Modification Request for the Uni. of Sydney
Abercrombie Precinct Redevelopment
Application No: MP07-0158 MOD3.

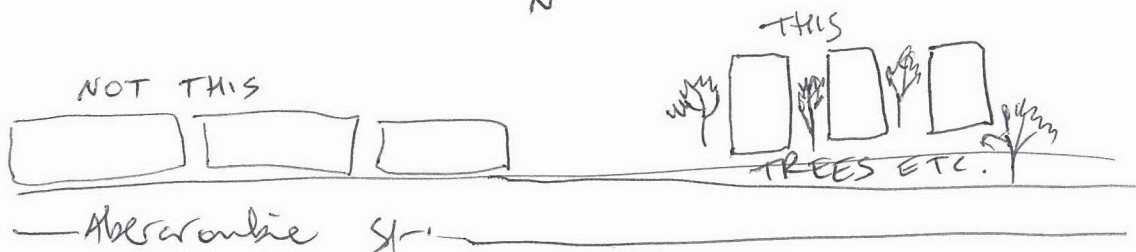
My main objection is that the frontage of the building faces east. For practical reasons (eg temperature control) it should face north.

The current three pods in the design should be separated, so that each pod faces north.

This might enable the Abercrombie St. frontage to be set back from the road further (appeasing the residents opposite)
